### **AMENDMENTS TO THE DRAWINGS**

Fig. 2

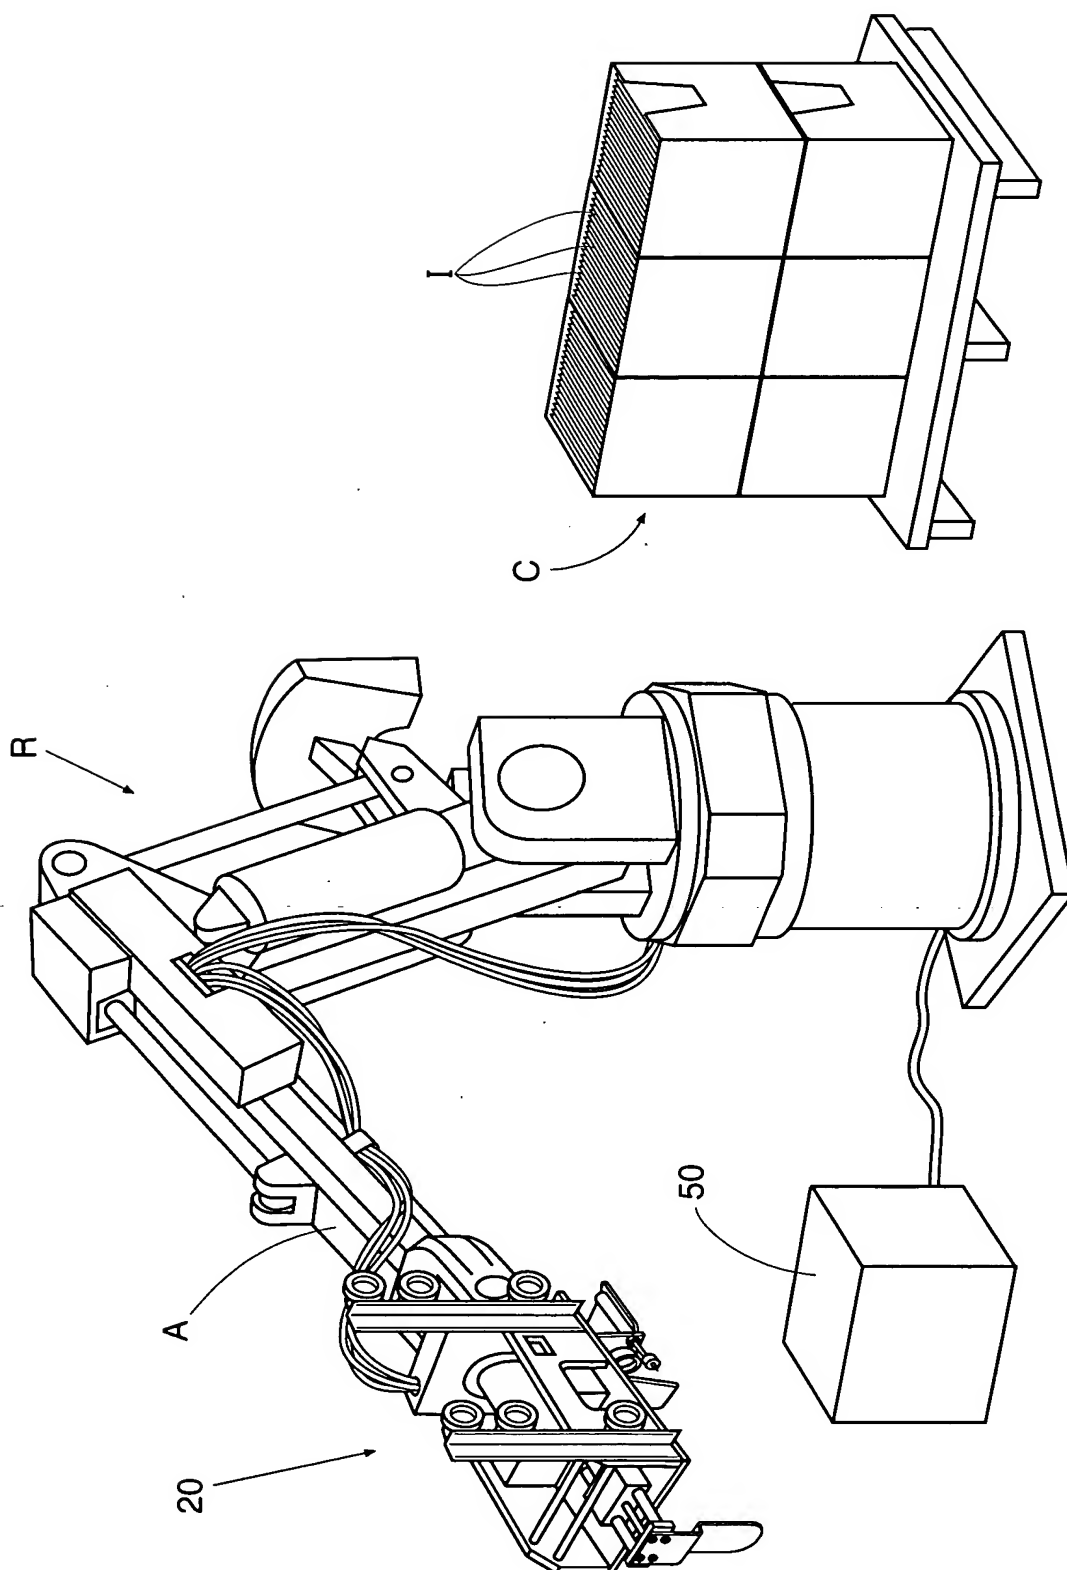
The drawings were objected to as failing to comply with 37 C.F.R. 1.84(b)(5) because they did not include certain reference numerals mentioned in the Specification. For instance, the numeral "50" was improper as it originally referred to the controller (i.e. see Figure 2), the wrist spacer is more properly referred to by the numeral "48" as used throughout the Specification, and particularly page 11.

The enclosed complete set of drawings includes proposed drawing corrections submitted to correct the objection. No new matter has been added. The numerals that have been placed on the drawings correspond to the discussion in the Specification. No new matter has been added to the Specification.
